**MONTGOMERY COUNTY HISTORIC PRESERVATION COMMISSION**  
**STAFF REPORT**

<b>Address:</b>	12 East Melrose, Chevy Chase	<b>Meeting Date:</b>	4/26/2023
<b>Resource:</b>	Contributing Resource Chevy Chase Village Historic District	<b>Report Date:</b>	4/19/2023
<b>Applicant:</b>	Laura Braden	<b>Public Notice:</b>	4/12/2023
<b>Review:</b>	HAWP	<b>Tax Credit:</b>	N/A
<b>Permit Number:</b>	1028583	<b>Staff:</b>	Dan Bruechert
<b>Proposal:</b>	Fence Installation

Figure 2: Proposed fencing on-site - 6' fence shown in red, recommended limits outlined in blue.

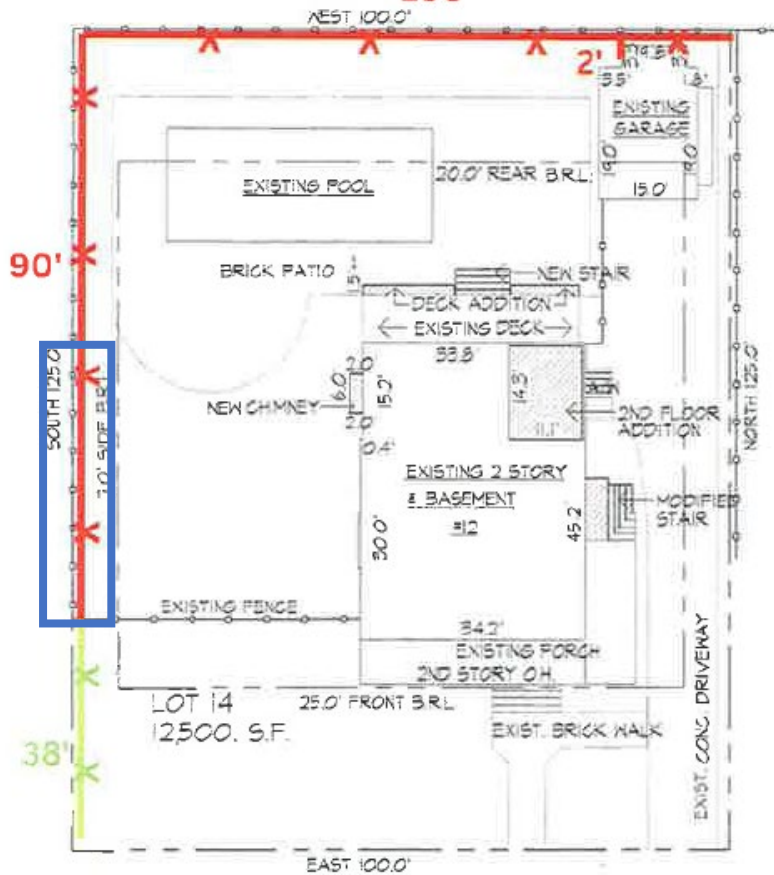
The HPC generally requires fences in the Chevy Chase Historic District that are forward of the rear wall plane to be no taller than 4' (four feet) and have an open picket design to preserve the district's character-defining, open park-like setting. In select instances, the HPC has allowed taller fences where there are needed to satisfy code requirements, but those fences also need to have an open picket character. Staff finds the proposed 6' (six foot) fence along the rear property line will not be visible from the public right of way and is appropriate under lenient scrutiny. Staff does not find all of the proposed solid board fencing along the left property boundary is compatible with the character of the district. While Staff finds a 6' (six foot) tall fence is consistent with the existing fence across the left side yard, the solid appearance does not contribute to the district's open, park-like setting. Several fence designs could be acceptable under the guidance. Staff recommends the HPC include a condition on the approval of this HAWP, requiring the fence along the left property line in front of the historic rear wall plane needs to have an open picket design and be painted. The approximate boundaries of Staff's recommendation are shown in *Fig. 2*, below). To the rear of the historic rear wall plane, the solid board fence is appropriate.

1. The proposed 4' picket fence needs to have a painted finish;
2. The fence along the left property boundary, in front of the rear wall plane, needs to have an open picket design and a painted finish;
